REVIEW	ISSUE	EVENT
25-03-2023		
GRAHAM		
NMANDD		
NEWRY		
TRAFFIC MANAGEMENT DETAILS		
TM SETUP FOR PARADE		
1-ARE ADVANCED NOTICE SIGNINGS SHOWN?		Y/N
2-ARE RELEVANT DECLAMERS SHOWN?		Y
3-ARE PONT LOCATIONS SHOWN?		Y
4-ARE PONT LOCATIONS SHOWN AT ROAD CLOSED SIGNS?		N/A
5-ARE MARSHALL LOCATIONS SHOWN AT ROAD CLOSED SIGNS?		Y
6-ARE MARSHALL LOCATIONS SHOWN AT CENTRE LINE SIGNS?		N/A
PSNI		
1-Marshalls at Road Closed Signs		
2-Marshalls to advise motorists of permitted movements - Le		
3-Marshalls to advise motorists of permitted movements - Le		
4-Marshalls to advise motorists of permitted movements - Le		
5-Marshalls to advise motorists of permitted movements - Le		
6-Marshalls to advise motorists of permitted movements - Le		
7-Marshalls to advise motorists of permitted movements - Le		
8-Marshalls to advise motorists of permitted movements - Le		
9-Marshalls to advise motorists of permitted movements - Le

10-Marshalls to advise motorists of permitted movements - Le		
EVENT ORGANISER		
EVENT TRAFFIC MANAGEMENT DOES NOT COMPLY WITH CH 8 PLEASE REFER TO CLAUSE 2.3 OF OUR TERMS OF BUSINESS FOR FURTHER INFORMATION		
N.T.S	1601/2023	CA
NEWRY ST PATRICKS PARADE - 01		
0

PARADE - 06

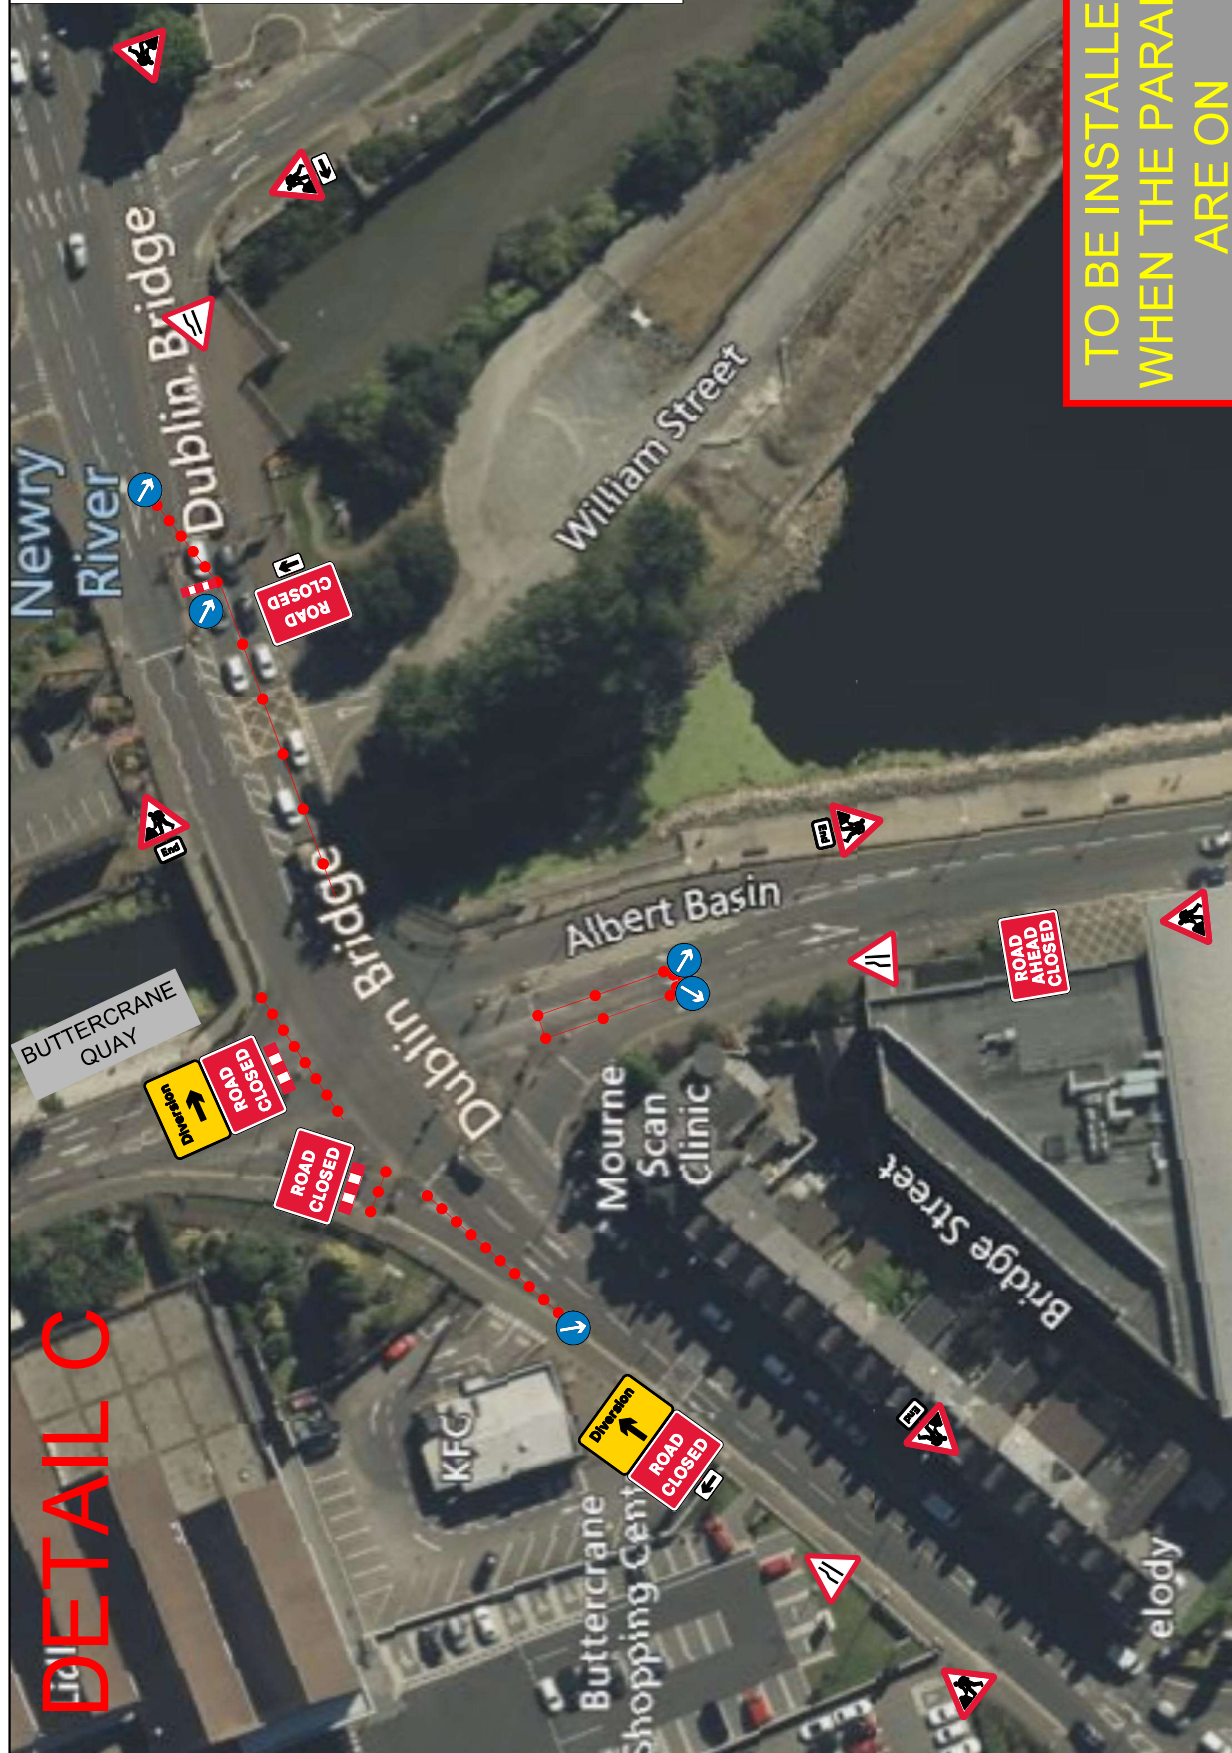
NMANDD			
NEWRY			
TRAFFIC MANAGEMENT DETAILS			
TM SETUP FOR PARADE			
DATE & GROUP	Y/N		
1- ARE ADVANCED NOTICE SIGNWAYS SHOWN?	Y		
2- ARE ADVANCED NOTICE SIGNWAYS SHOWN?	Y		
3- ARE RELEVANT DISCLAIMERS SHOWN?	N/A		
4- ARE PSNI LOCATIONS SHOWN?	Y		
5- ARE PSNI LOCATIONS SHOWN?	N/A		
6- ARE MARSHALL LOCATIONS SHOWN AT ROAD CLOSED SENS?	Y		
7- ARE MARSHALL LOCATIONS SHOWN AT CENTRE LINE SENS?	N/A		
8- ARE MARSHALL LOCATIONS SHOWN AT CENTRE LINE SENS?	N/A		
PSNI			
● Marshall at Road Closed Signs (Marshall to advise motorists of permitted movements - i.e no vehicles allowed onto marathon route from a side street)			
● Marshall at Centre Line Closing (Marshall to advise motorists of permitted movements - i.e vehicles from side streets only allowed to turn left)			
EVENT ORGANISER			
EVENT TRAFFIC MANAGEMENT DOES NOT COMPLY WITH CH 8. PLEASE REFER TO CLAUSE 2.5 OF OUR TERMS OF BUSINESS FOR FURTHER INFORMATION

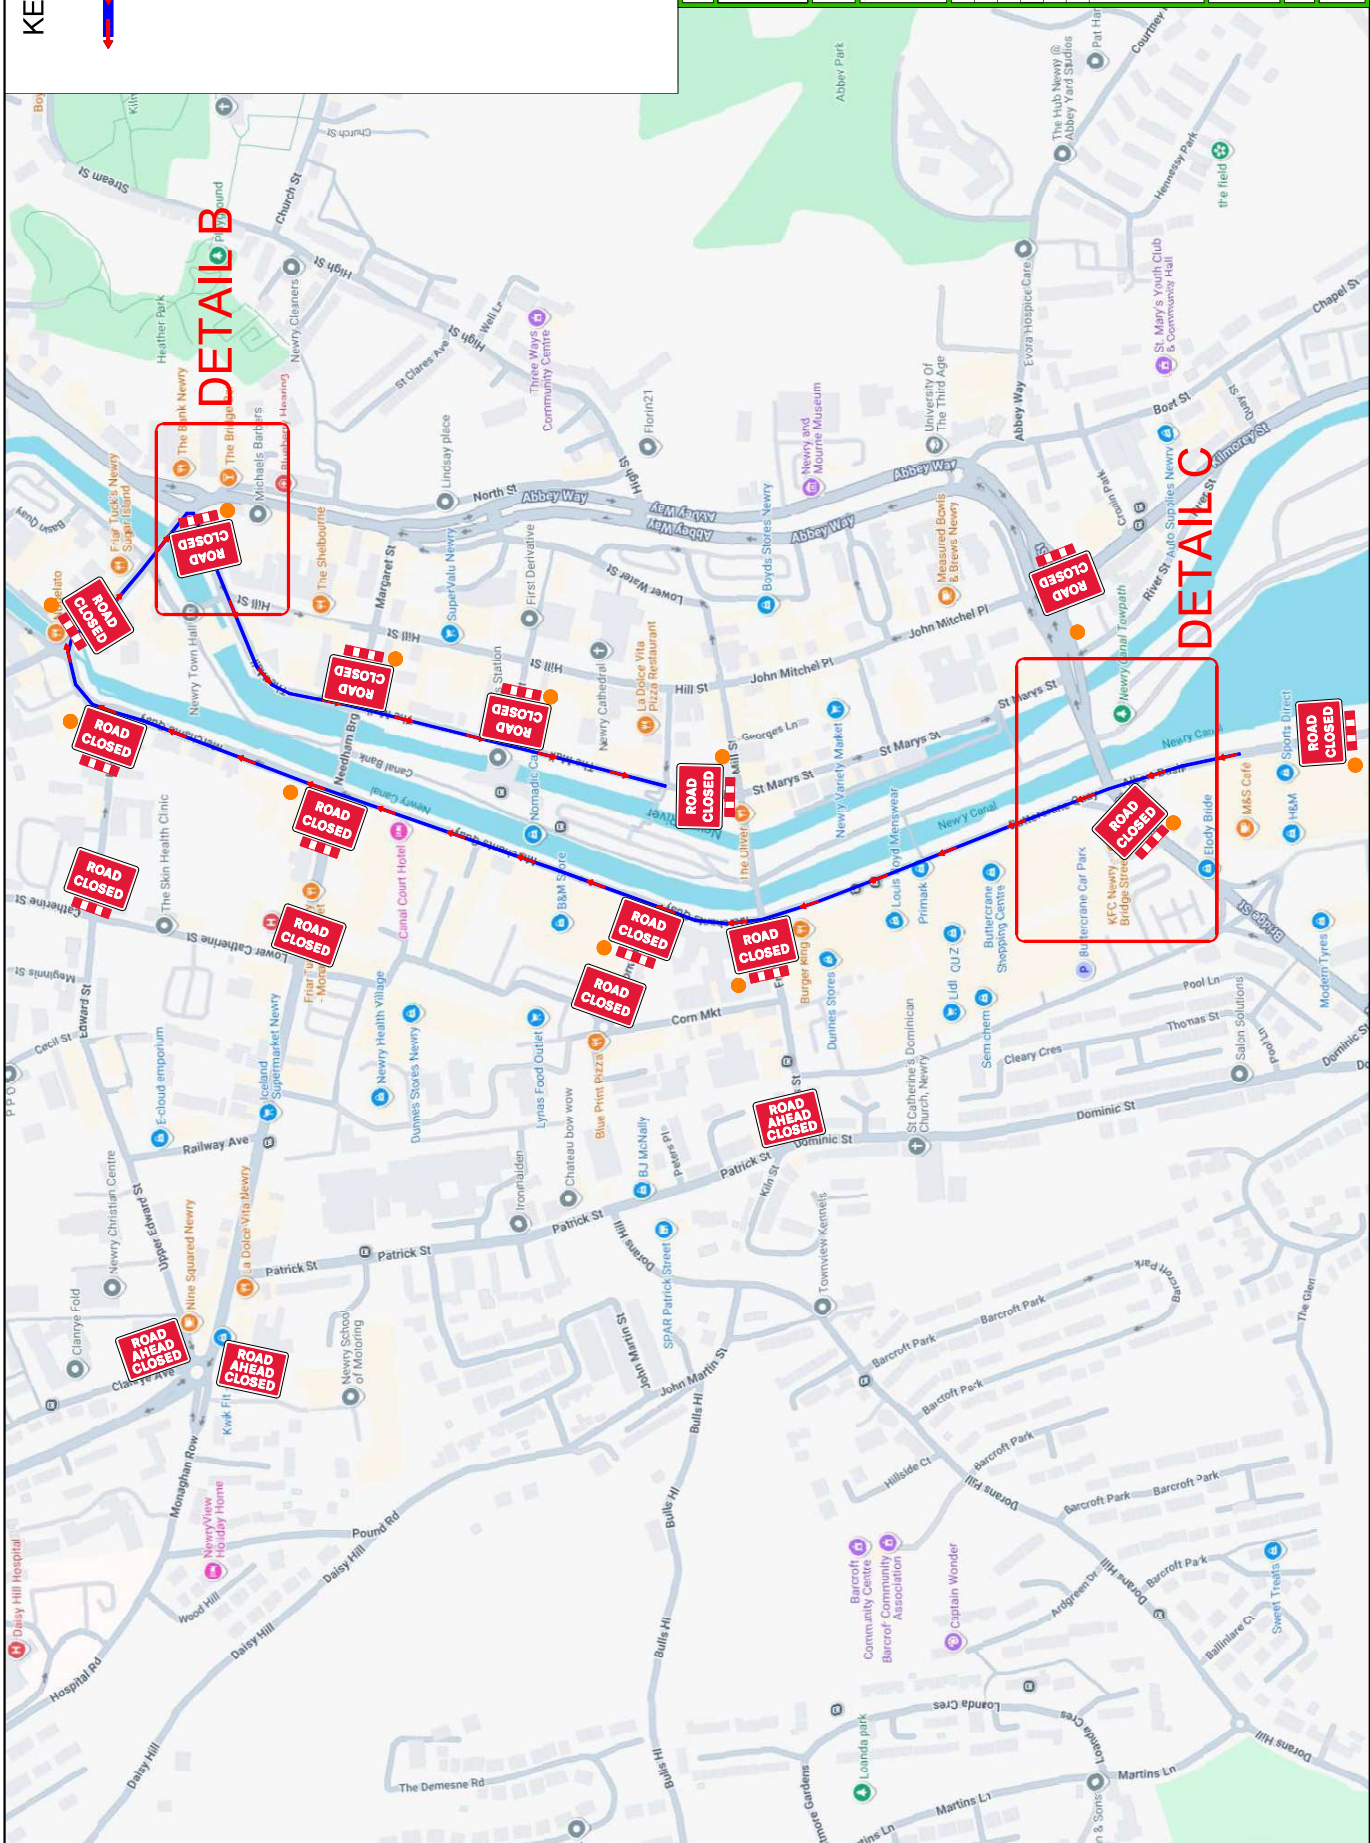
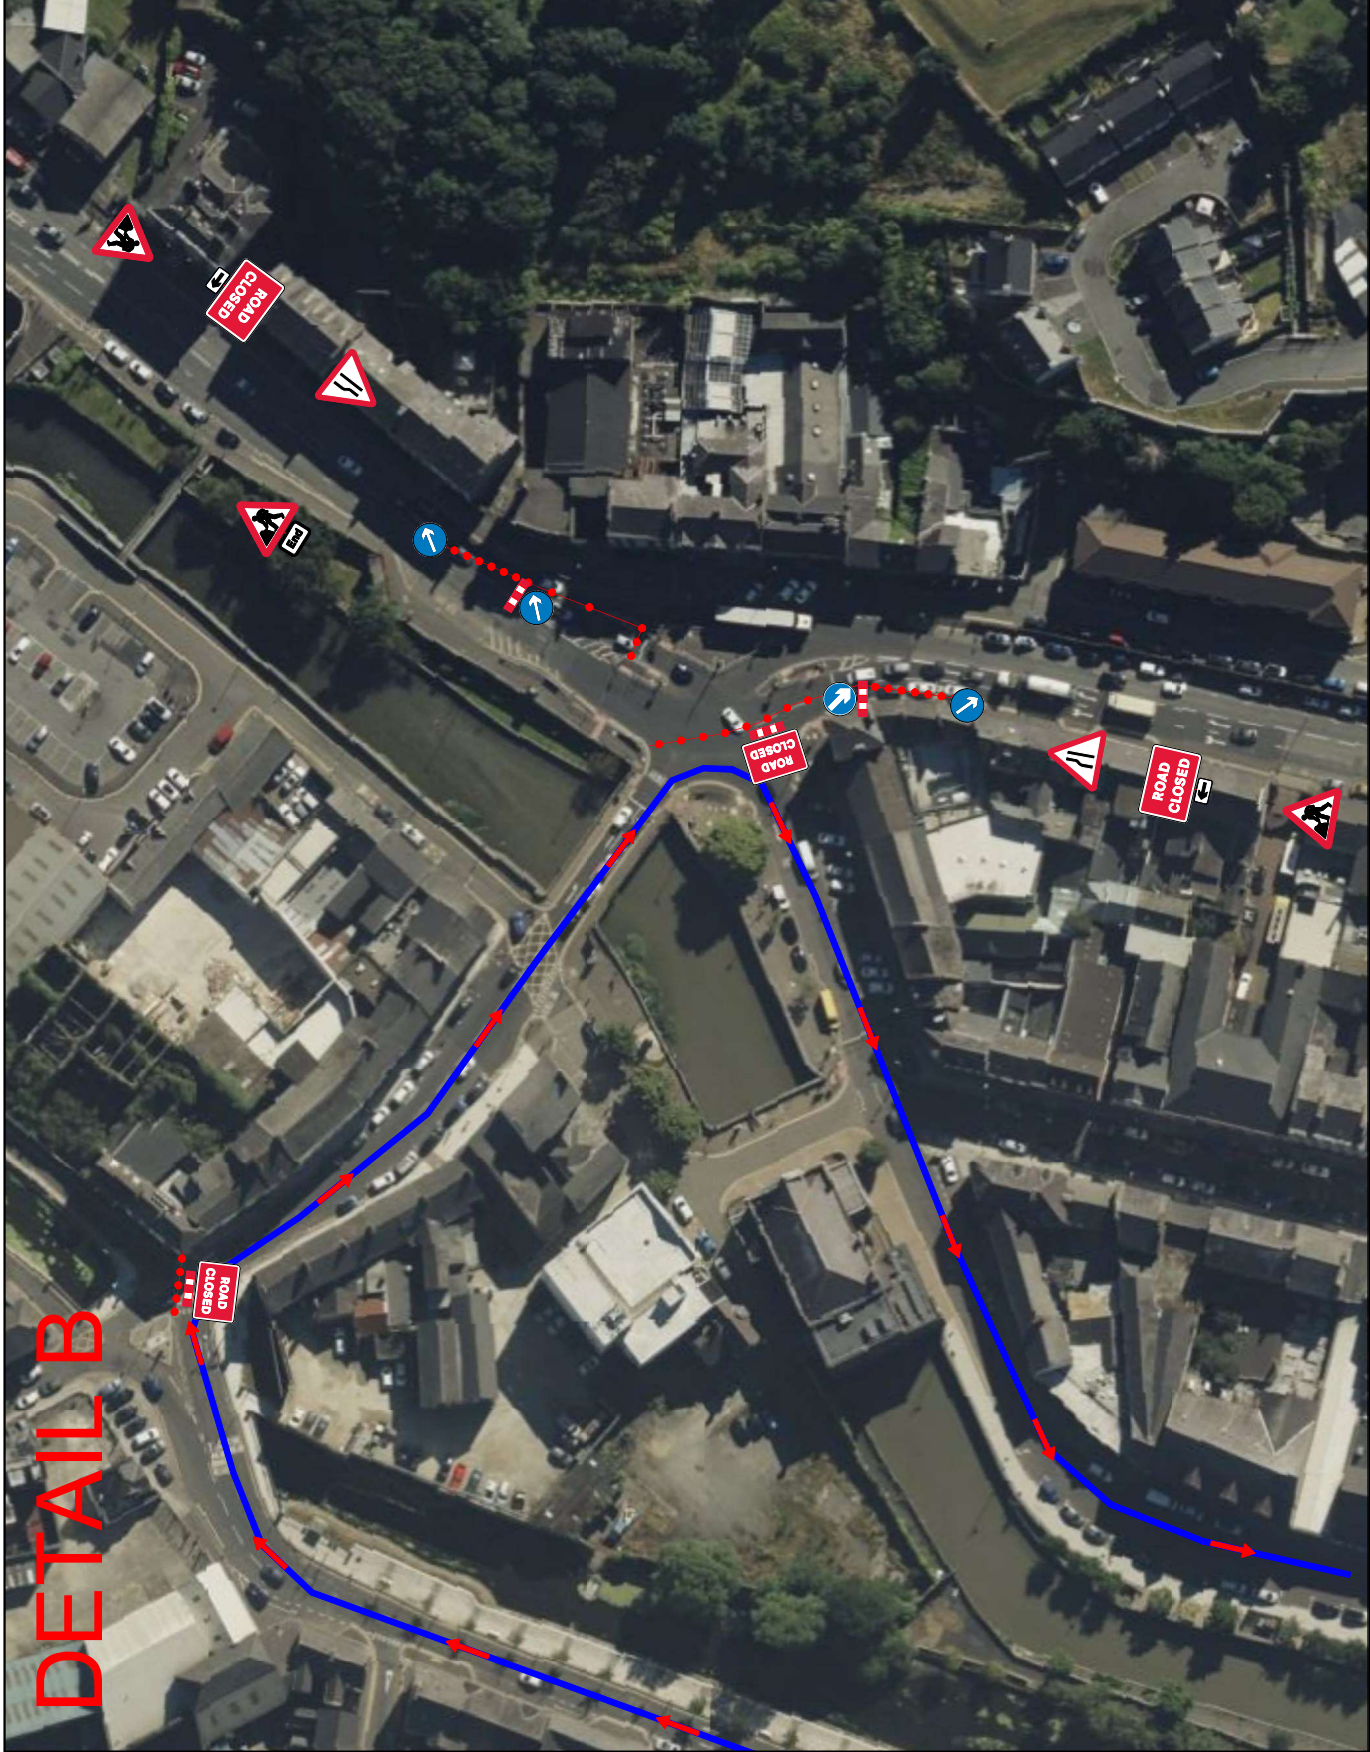
REVIEW	EVENT
5/14/2023	
GRAHAM	
PROJECT	NMANDD
TITLE	NEWRY
TRAFFIC MANAGEMENT DETAILS	
TM SETUP FOR PARADE	
1-ARE ADVANCED NOTICE SIGNWMS SHOWN?	Y/N
2-ARE RELEVANT DECLAMERS SHOWN?	Y
3-ARE POINT LOCATIONS SHOWN?	Y
4-ARE MARSHALL LOCATIONS SHOWN AT ROAD CLOSED SIGNS?	N/A
5-ARE MARSHALL LOCATIONS SHOWN AT CENTRE LINE SIGNS?	Y
6-ARE MARSHALL LOCATIONS SHOWN AT CENTRE LINE SIGNS?	N/A
PSNI	
● Marshalls at Road Closed Signs	
● Marshalls to advise motorists of permitted movements - Le	
● no vehicles allowed onto marathon route from a side street	
● Marshalls at Centre Line Coning	
● Marshalls to advise motorists of permitted movements - Le	
● vehicles from side streets only allowed to turn left	
EVENT ORGANISER	
EVENT TRAFFIC MANAGEMENT DOES NOT COMPLY WITH CH 8 PLEASE REFER TO CLAUSE 2.3 OF OUR TERMS OF BUSINESS FOR FURTHER INFORMATION	
CA	CA
N.T.S	1601/2023
NEWRY ST PATRICKS	PARADE - 04
0

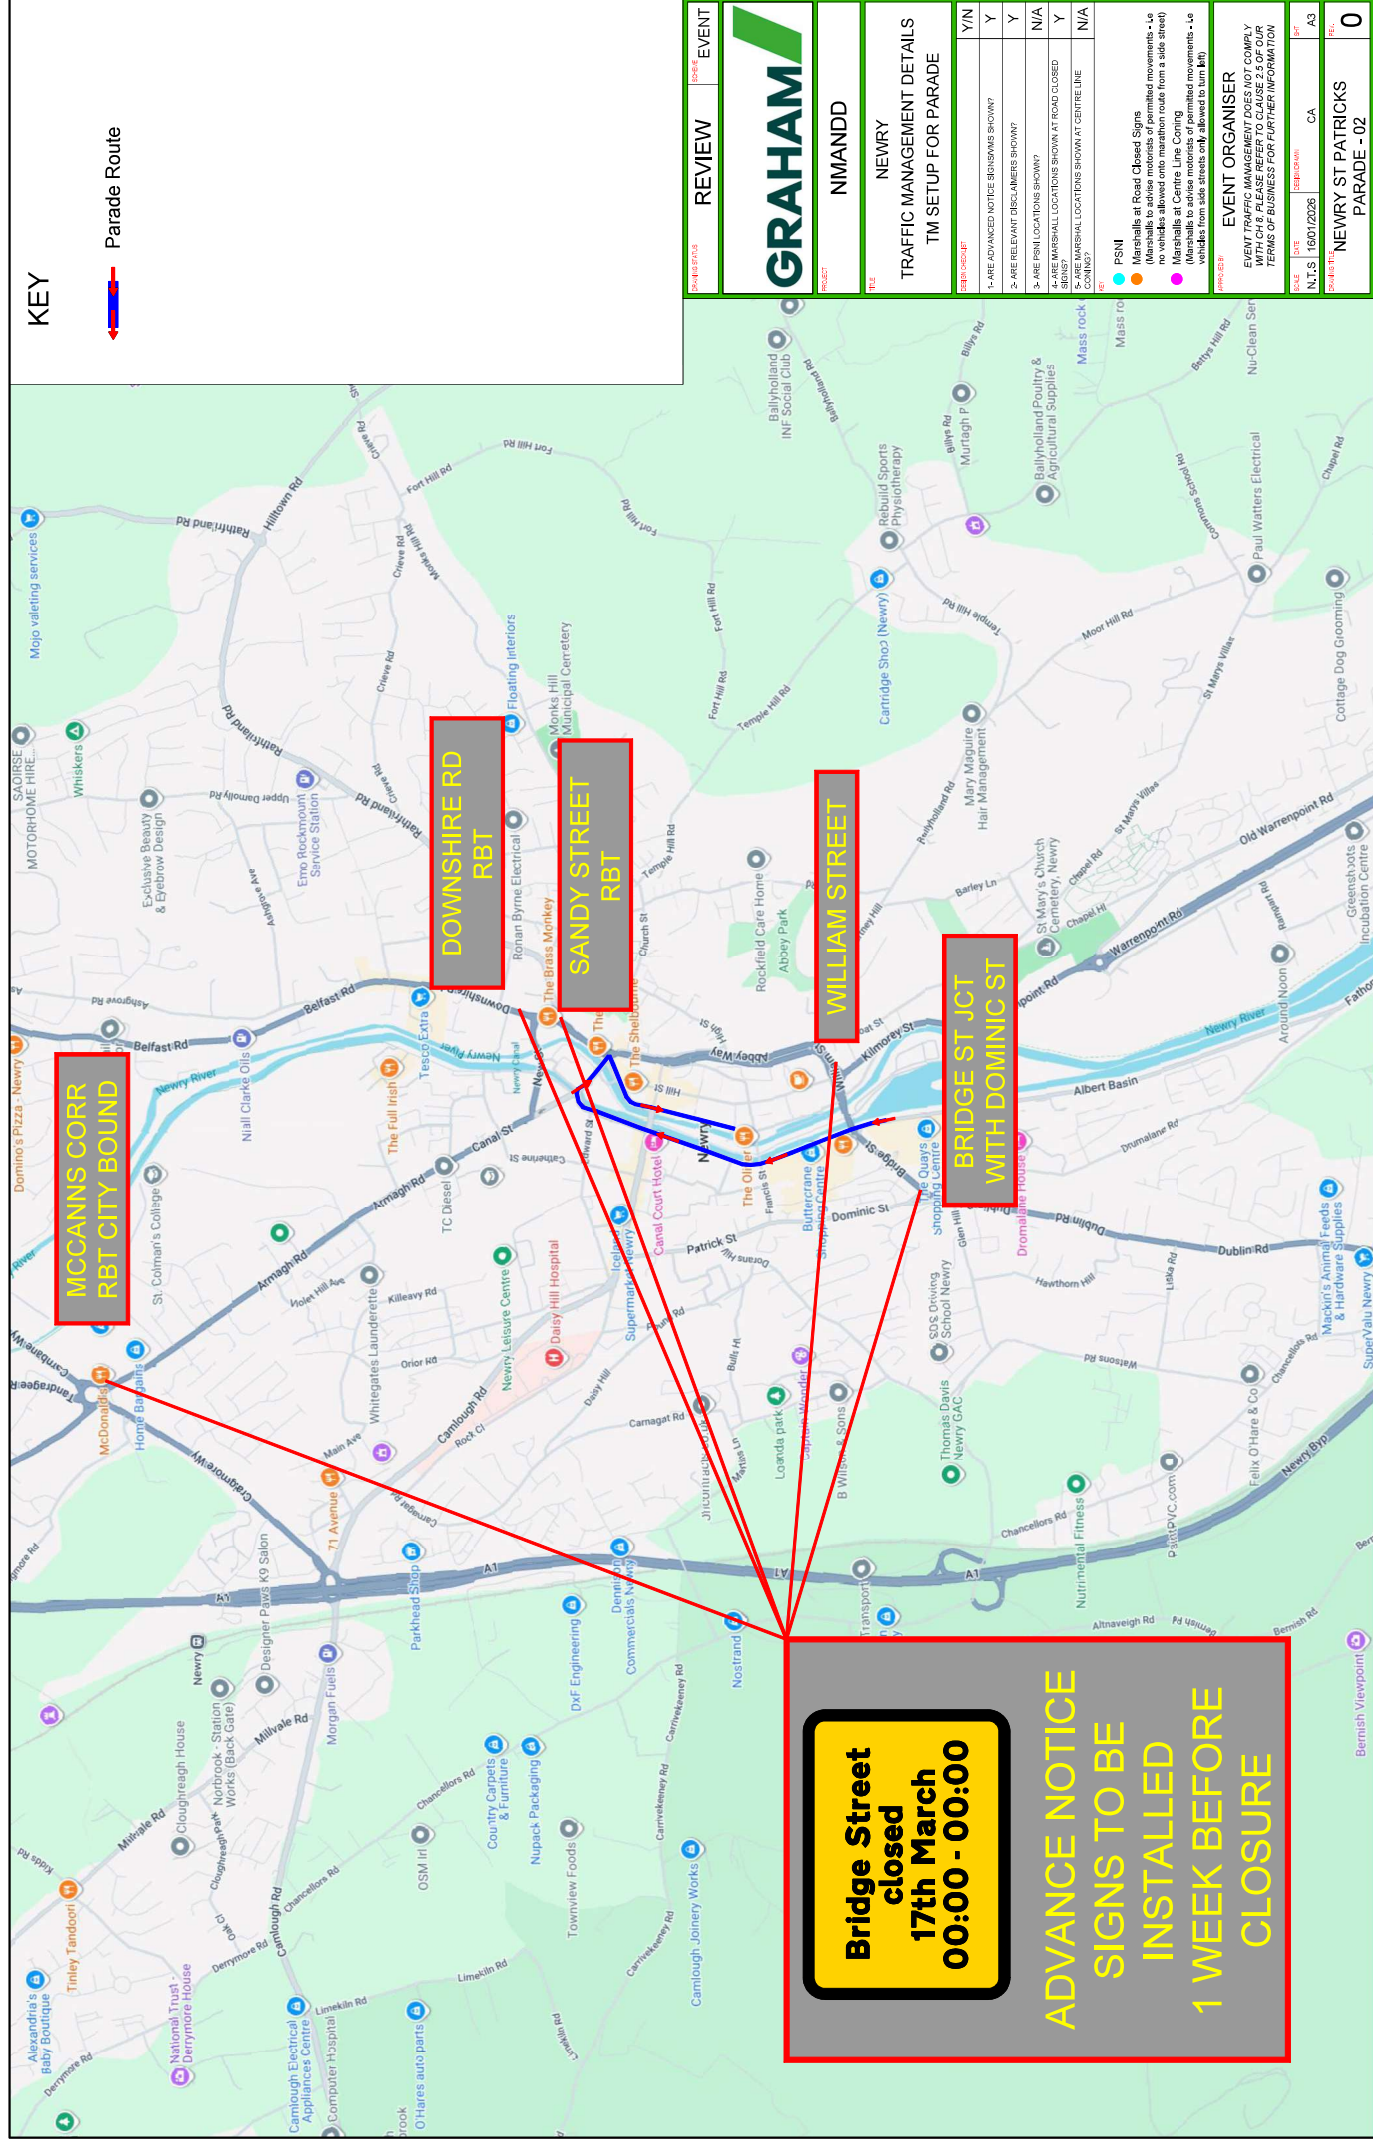
REVIEW	EVENT
5/24/2024	
PROJECT	GRAHAM
PRODUCT	NMANDD
TITLE	NEWRY
TRAFFIC MANAGEMENT DETAILS	
TM SETUP FOR PARADE	
PSNI GROUP	Y/N
1- ARE ADVANCED NOTICE SIGNWMS SHOWN?	Y
2- ARE RELEVANT DECLARATIONS SHOWN?	Y
3- ARE POINT LOCATIONS SHOWN?	N/A
4- ARE MARSHALL LOCATIONS SHOWN AT ROAD CLOSED SIGNS?	Y
5- ARE MARSHALL LOCATIONS SHOWN AT CENTRE LINE SIGNS?	N/A
PSNI	
● Marshalls at Road Closed Signs	
● Marshalls to advise motorists of permitted movements - Le	
no vehicles allowed onto marathon route from a side street	
● Marshalls at Centre Line Coning	
(Marshalls to advise motorists of permitted movements - Le	
vehicles from side streets only allowed to turn left)	
EVENT ORGANISER	
EVENT TRAFFIC MANAGEMENT DOES NOT COME WITH CH 8 PLEASE REFER TO CLAUSE 2.4 OF OUR TERMS OF BUSINESS FOR FURTHER INFORMATION	
DATE	16/01/2024
TIME	CA
LOCATION	NEWRY ST PATRICKS
PROJECT	PARADE - 05
0
